Access Compliance Report

Public Rights-of-Way

(Curb Ramps)

Intersection ID: 25678	Main Street: CARMEL_EXECUTIVE_PARK	Cross Street: LITTLE_AV	Location: SW
ADA ID: 7A25D93A202A	Ramp Type: Perp	Initial Pass/Fail: Fail	Overall Compliance: No
Severity Score: 21.25			
Codes/Mitigation Info/Possible Solution		Field Measurements/Component Compliance

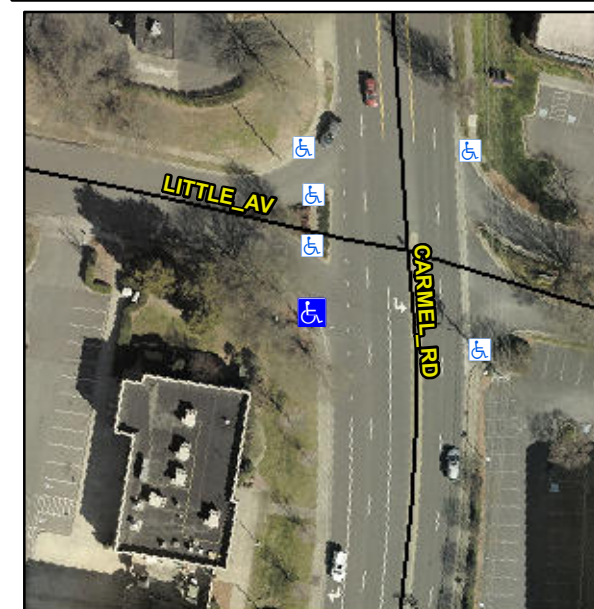
Not Found, R304.5.1, R304.2.2

Compliance	Description	Data	Compliance	Description	Data
N/A	Ramp Length (in)	60.0	No	Ramp Slope (%)	8.8
No	Ramp Width (in)	45.0	Yes	Ramp XSlope (%)	0.3
N/A	Flare Type LT	N/A	N/A	Flare Type RT	N/A
N/A	Flare Slope LT (%)	N/A	N/A	Flare Slope RT (%)	N/A
N/A	Flare Traversable LT?	N/A	N/A	Flare Traversable RT?	N/A
N/A	Landing Length (in)	N/A	N/A	DWS Provided?	N/A
N/A	Landing Width (in)	N/A	N/A	DWS Contrast?	N/A
N/A	Landing Slope (%)	N/A	N/A	DWS Length (in)	N/A
N/A	Landing X Slope (%)	N/A	N/A	DWS Full Width?	N/A
N/A	Landing Curb? (Y/N)	N/A	N/A	DWS Offset (in)	N/A
N/A	Shared Landing?	N/A			
N/A	Gutter Ponding?	N/A	N/A	Gutter Slope (%)	N/A
N/A	Gutter Lip Ht (in)	N/A	N/A	Gutter X Slope (%)	N/A
N/A	Painted X Walk1?	No	N/A	Painted X Walk2?	N/A
	X Walk 1 Direction	To N		X Walk 2 Direction	N/A
N/A	X Walk 1 Width (in)	N/A	N/A	X Walk 2 Width (in)	N/A
	X Walk 1 Slope (%)	0.8		X Walk 2 Slope (%)	N/A
	X Walk 1 X Slope (%)	1.9		X Walk 2 X Slope (%)	N/A

Remove & Replace Entire Ramp.
